## Planning Commission Staff Report

<b>Project Type:</b>	Amended Site Development Plan
<b>Meeting Date:</b>	August 12, 2019
<b>From:</b>	Mike Knight, Planner
<b>Location:</b>	A 5.0 acre tract of land located south of Chesterfield Airport Road, east of Chesterfield Commons East Road and west of Baxter Road.
<b>Description:</b>	<b><u>Storage Masters Chesterfield Self Storage (ASDP)</u></b> : An Amended Site Development Plan, Landscape Plan, Lighting Plan, Architectural Elevations and Architect's Statement of Design for a 5.0 acre tract of land located south of Chesterfield Airport Road, east of Chesterfield Commons East Road and west of Baxter Road. (17T240188).

This request is to allow for the demolition of the existing leasing/sales office and replacing it with a new slightly smaller leasing/sales office. The owner's objective is to begin one of a series of property upgrades to the subject site. The site is 5 acres, consisting of 10 buildings with sole access off of Chesterfield Airport Road.

Figure 2: Color Site Plan

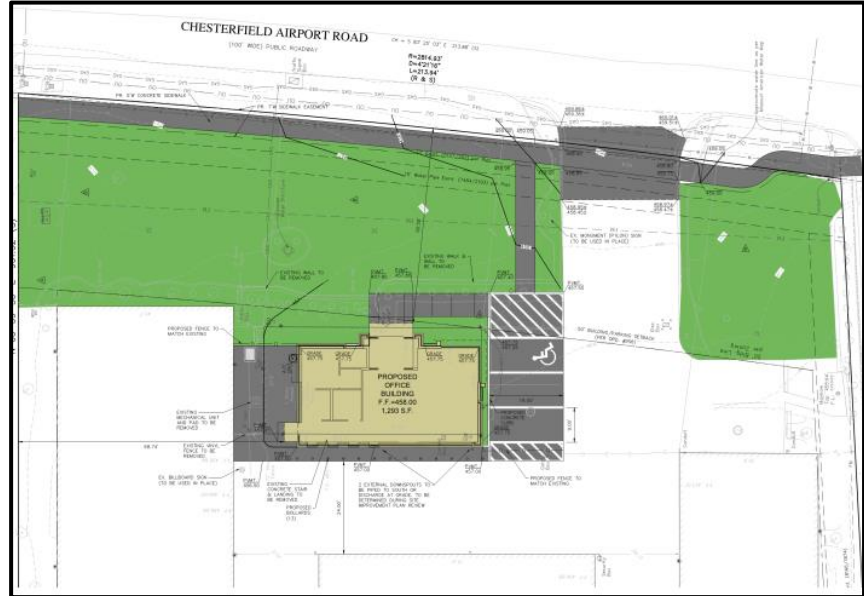
The scope of work is limited to a small portion of the site (Figure 2), along the frontage of Chesterfield Airport Road. The proposed structure is situated approximately in the same location as the existing structure with a slightly smaller footprint. The new appearance of the building enhances the compatibility with surrounding commercial developments within the Chesterfield Valley.

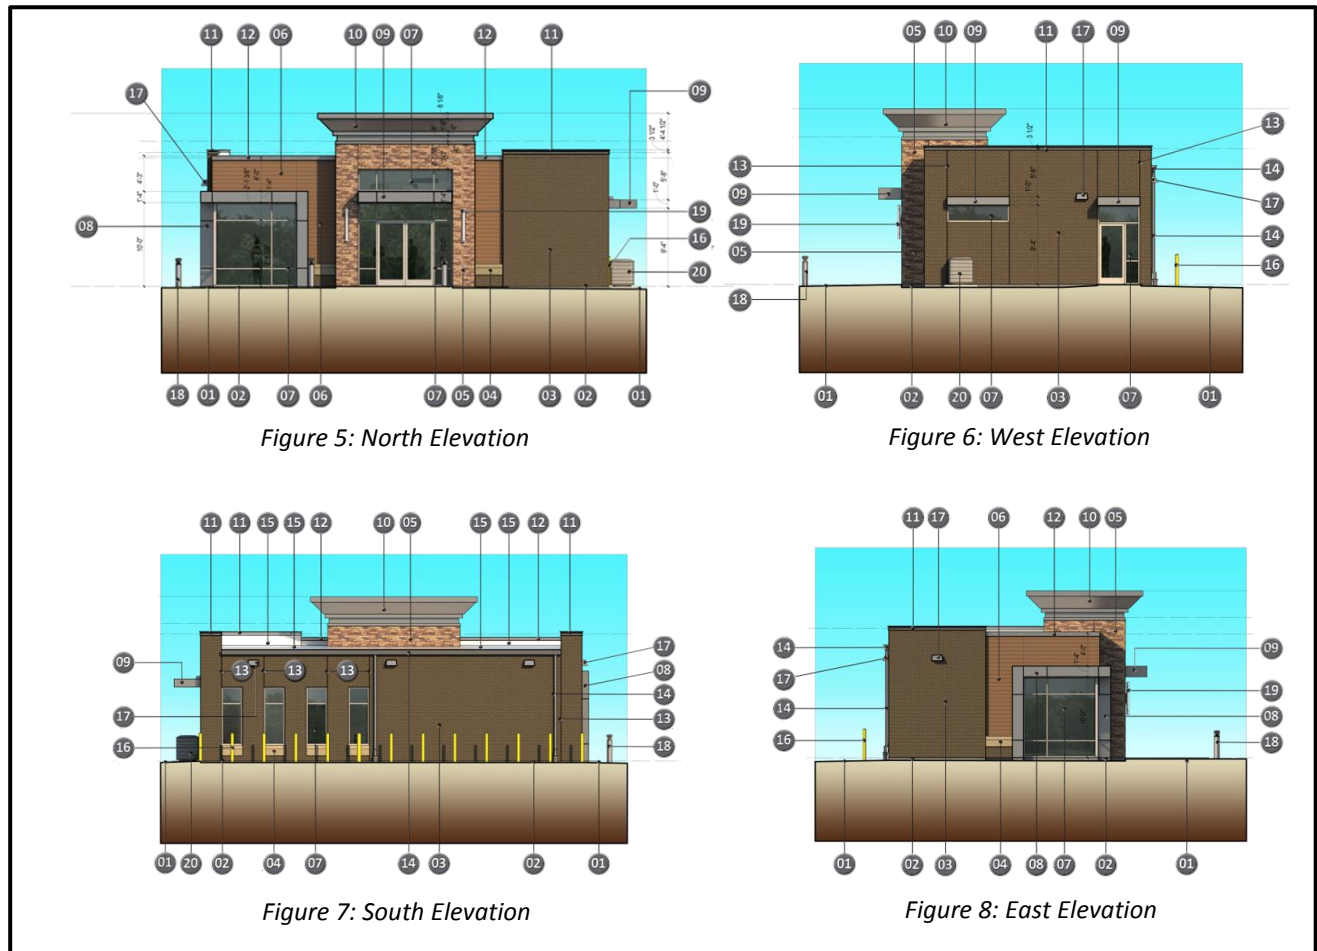
The intent of this project is to update the leasing/sales office to a more modern design with similar building materials of neighboring structures. The building will change dramatically in color and form,

but not in square footage. The building is constructed in a mix of materials mentioned in the next section. As mentioned in the project narrative, the applicant states this is intended to be one of a series of updates to the property.
